**Subject** ▶ Change of Slider and Plane Bearing

**For Models** ▶ JR3000 (Recipro Saws)

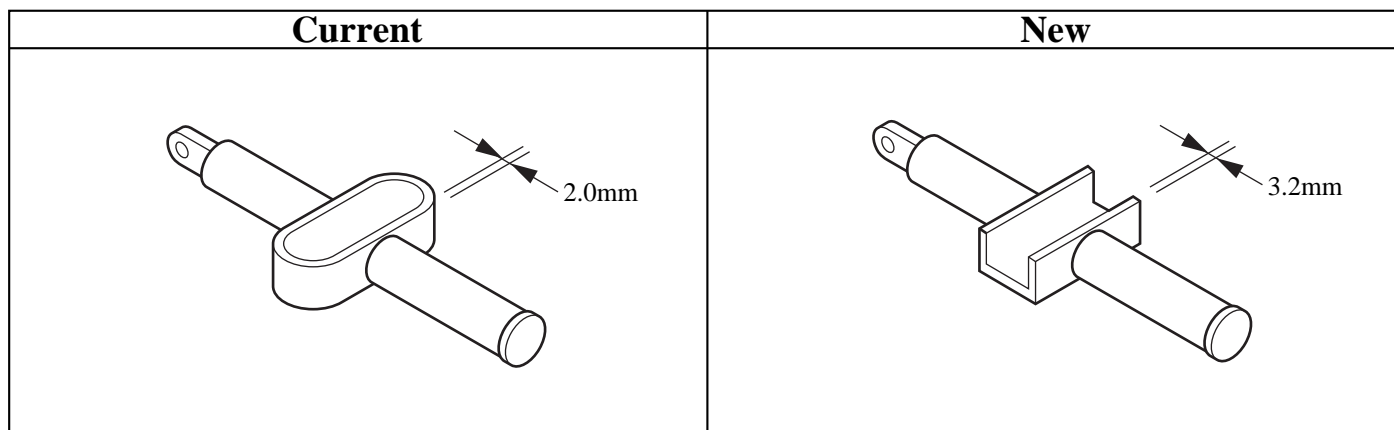
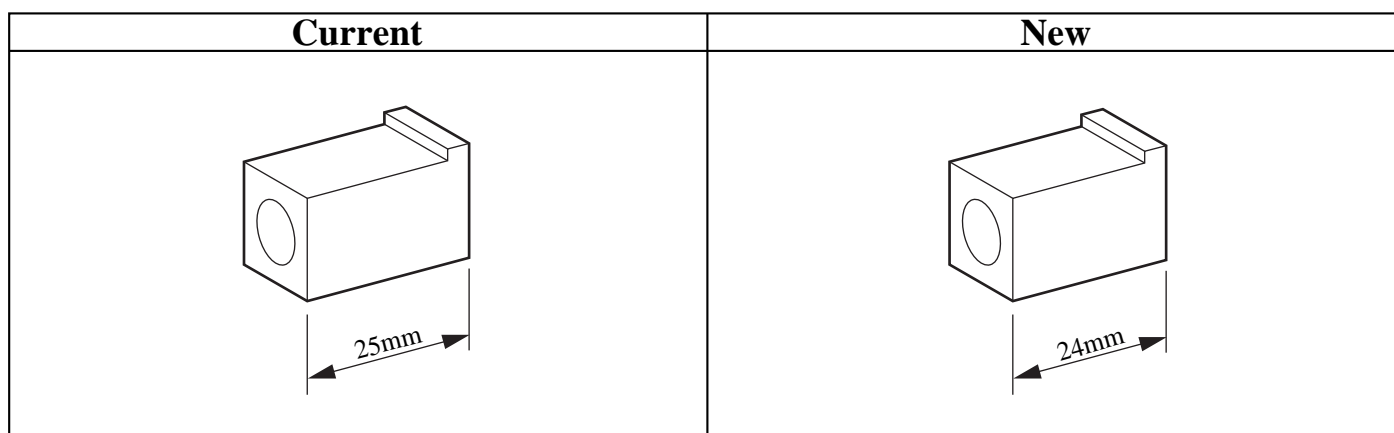
1) Change on Slider : Shape and thickness of slider block have been changed.

2) Change on Plane Bearing 12.7 : Plane Bearing at moter housing side has been shortened by 1mm to make a clearance for new Slider block.

Current Plane Bearing may be used only at blade side after above change.
